City of Biddeford
Planning Board
February 21, 2024 6:00 PM City Hall
Council Chambers, & Zoom
<https://biddeford.zoom.us/j/94983531202?pwd=Q3ZyejcyUVpBaUVVMHduYXJhSzB4UT09>
Webinar ID 949 8353 1202; Passcode 223739

RE: **2021.04 Final Subdivision and Site Plan Re-approval request for Adams Point Housing – Southern Maine Affordable Housing / 69 Adam’s Street (Tax Map 38, Lot 296) for 39 residential units.**

Peer Review Comments: We have undertaken a review of the Adams Street Housing submission. We reviewed it in the context of the Notice of Decision COA and the applicant’s September 22, 2021 response letter to Greg Tansley, copy attached.

1 LAYOUT PLAN
CL101 SCALE: 1"=20'

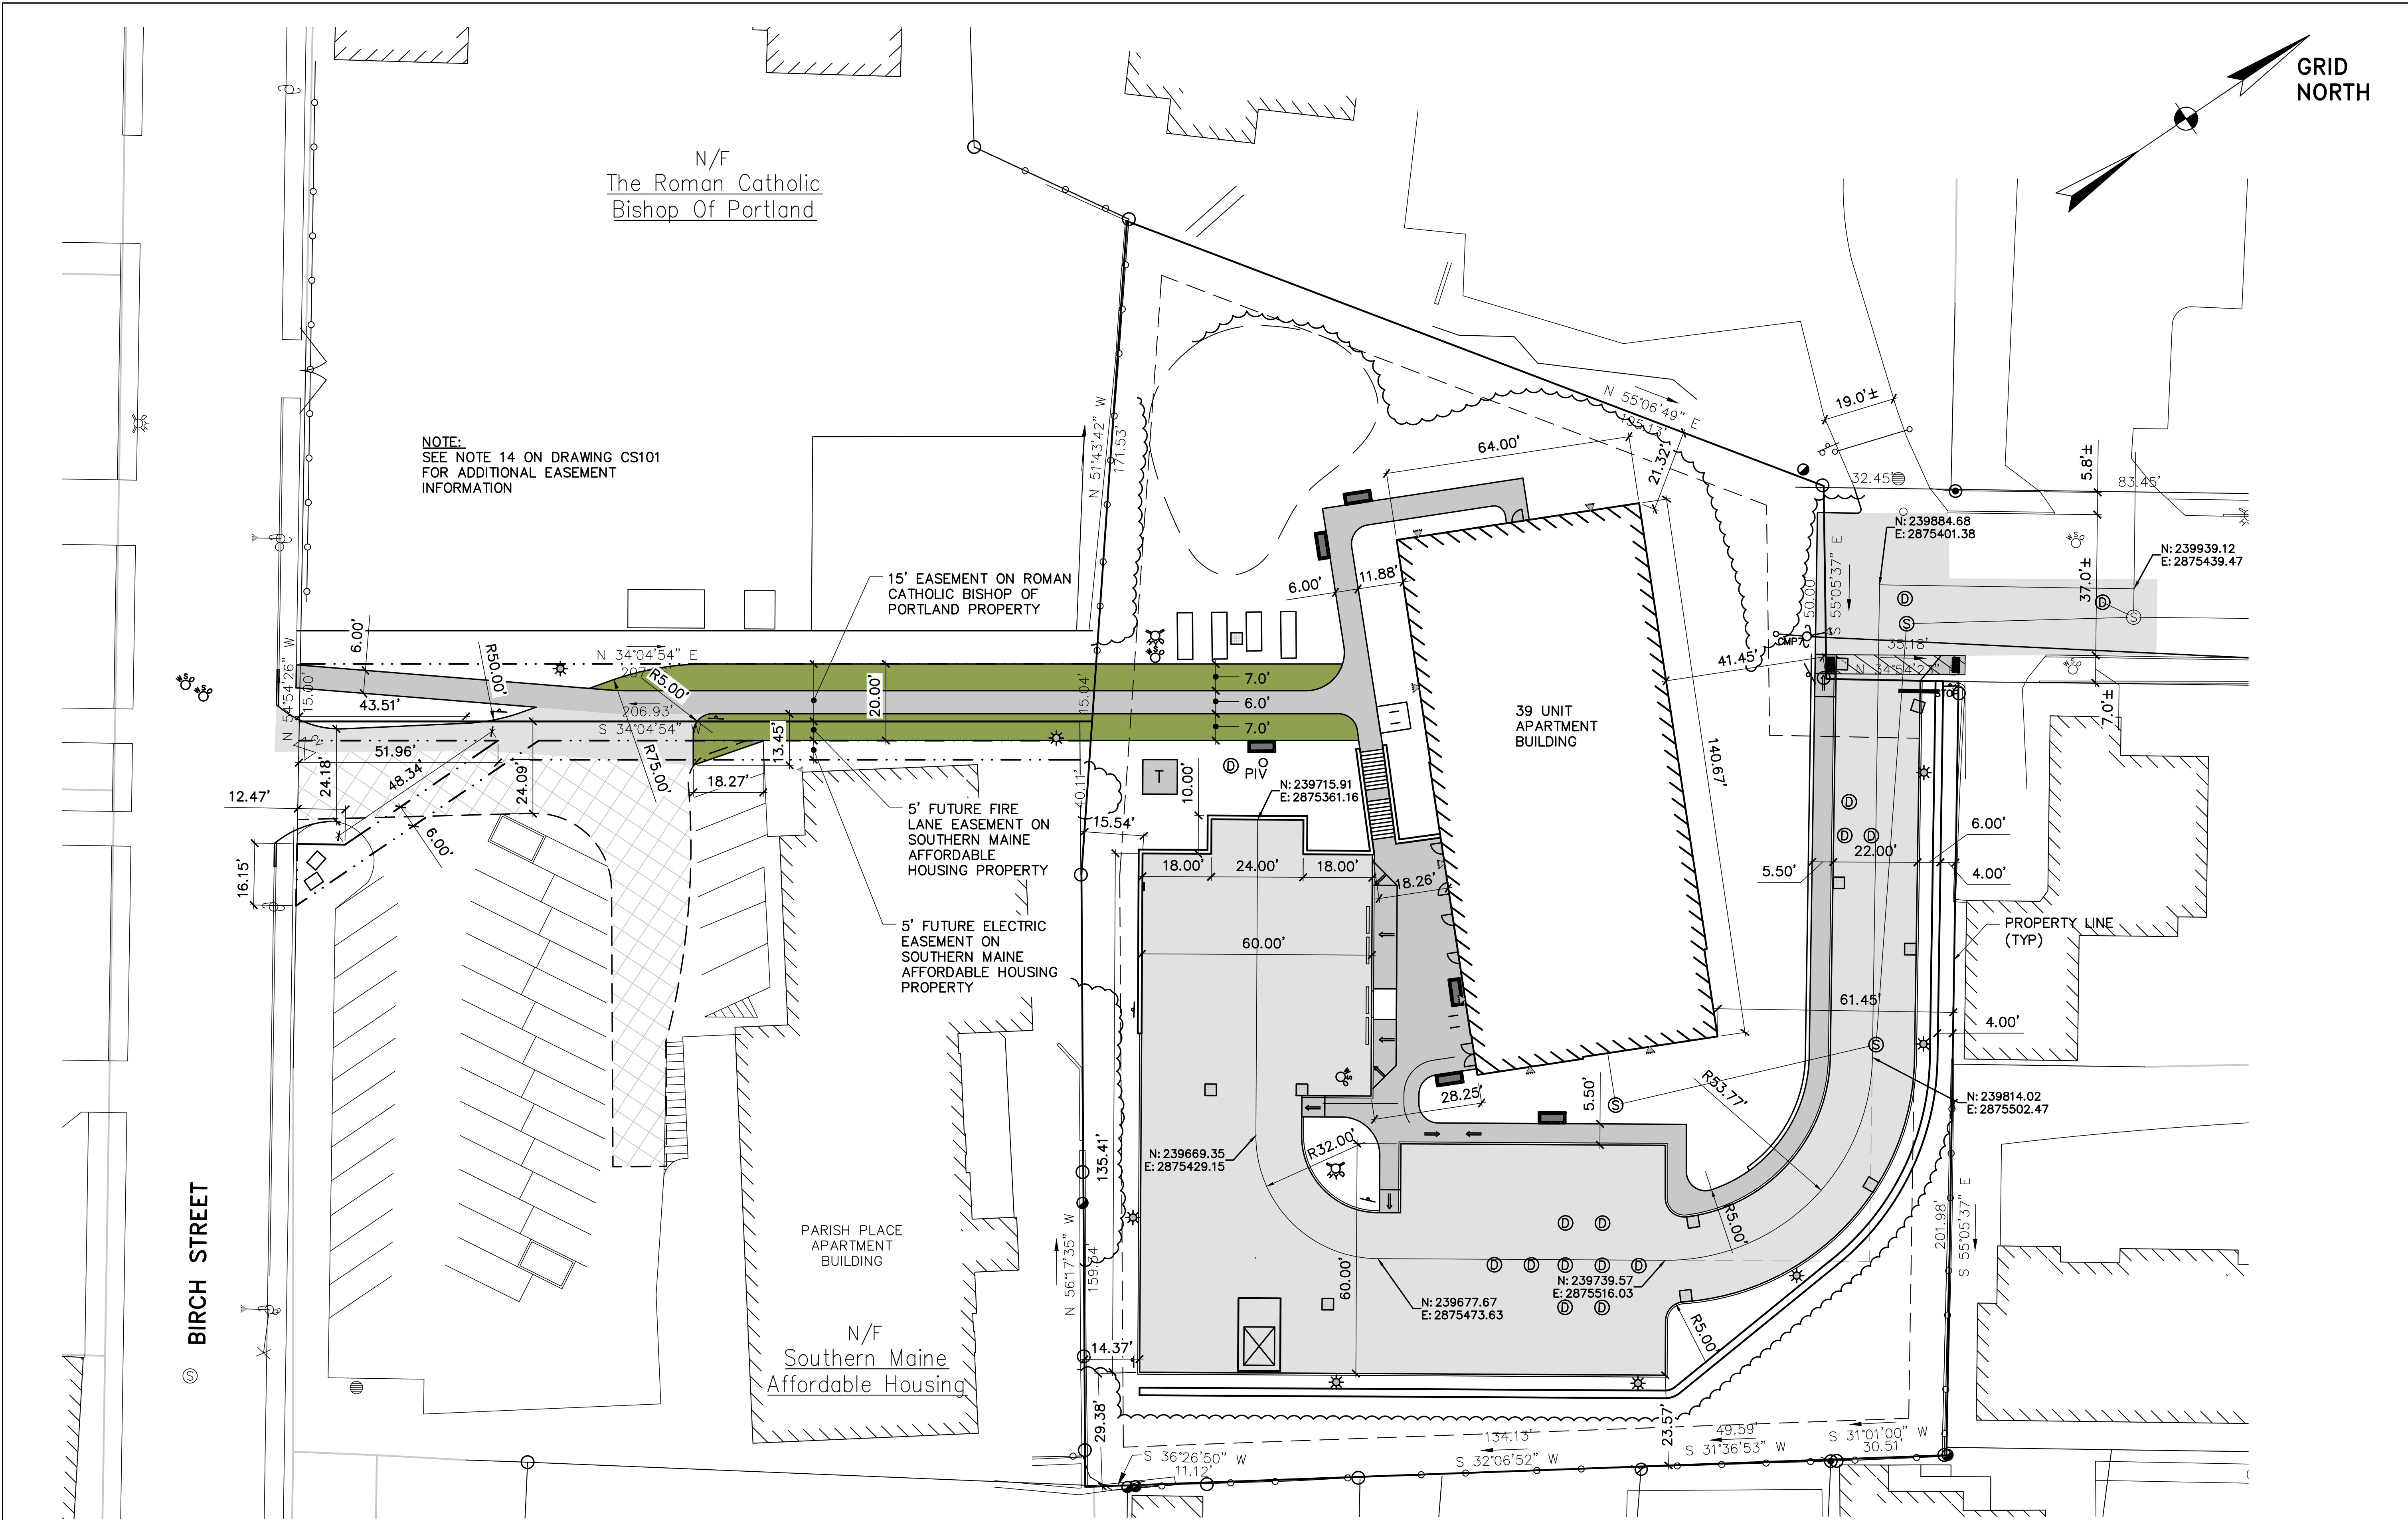
A.4.d. The plan seems to show a 22 ft wide drive, but the typical section has not been updated to reflect a 22 ft width.
